U.S. NUCLEAR REGULATORY COMMISSION
FINAL SAFETY EVALUATION (REVISED) FOR
TOPICAL REPORT WCAP-16996-P/WCAP-16996-NP, VOLUMES I, II, AND III, REVISION 1,
“REALISTIC LOSS-OF-COOLANT ACCIDENT EVALUATION METHODOLOGY
APPLIED TO THE FULL SPECTRUM OF BREAK SIZES” (TAC NO. ME5244)
WESTINGHOUSE ELECTRIC COMPANY
PROJECT NO. 700

Figure 1: A Characteristic PCT Response to Break Size Variation Observed in Analyses Using 10 CFR Part 50 Appendix K and in Power Uprate Small Break LOCA Analysis

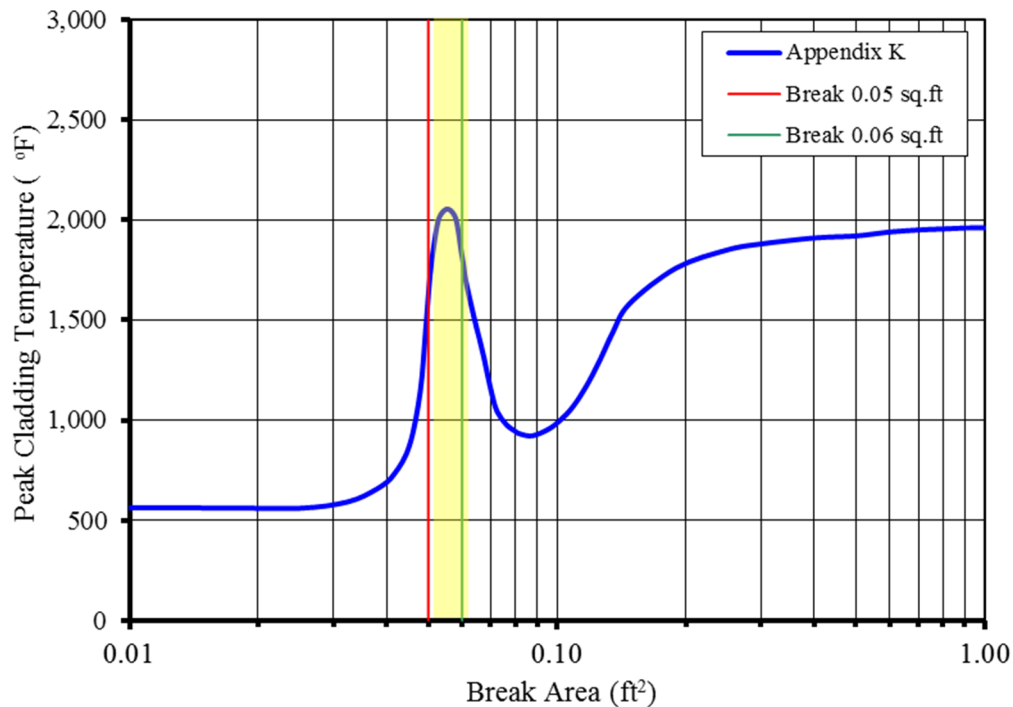
A typical small break spectrum analysis produces a characteristic PCT versus break size response, which is shown in Figure 1. Of particular significance in this response is the observed limiting break region with a maximum in the PCT at approximately 0.055 ft². The depicted PCT vs break size curve is typical of plants with low capacity high pressure safety injection pumps or those undergoing extended power uprates. It is important to further note that for some plants the predicted PCT can increase by a few hundred degrees Fahrenheit when the break size changes within the limiting break region from approximately 0.05 ft² to 0.06 ft². For example, it has been observed for many PWR plants that the PCT can increase by ~100 °F when the break area changes by as little as 0.005 ft² within this break region so that the PCT at a 0.055 ft² break is considerably higher than the PCTs at both 0.05 ft² and 0.06 ft² breaks. Furthermore, this limiting break region is characterized by a RCS pressure that depressurizes to a pressure value just above the safety injection tank (SIT) or accumulator actuation pressure. Because such behavior characterizes a large number of PWR plants, it is necessary to resolve the limiting break region confining the worst break controlled entirely by the high pressure injection pump. The core uncover period for breaks in this limiting range of relatively small breaks can be as long as 45 minutes to one hour. For some plants, the two-phase mixture level in the core can recede slowly to depths near the core mid-plane during this period. Such long term core uncover LOCAs emphasize the significance of the BE two-phase level swell modeling and PCT, controlled by interfacial drag, steam cooling heat transfer, loop seal clearing behavior, decay heat, and condensation at the safety injection port, to name the most significant. Clearly, with the core being uncovered for a period of up to one hour, very small changes in the core two-phase mixture level during such uncover periods can result in very large PCT changes.

Given the above discussed issues and the fact that the WCOBRA/TRAC-TF2 code has no proven history of successful simulation of SBLOCAs, the NRC staff formulated the following approach to identifying and analyzing the limiting break region for the SBLOCA spectrum as illustrated in Figure 1. The entire small break spectrum (Region I) is defined as:
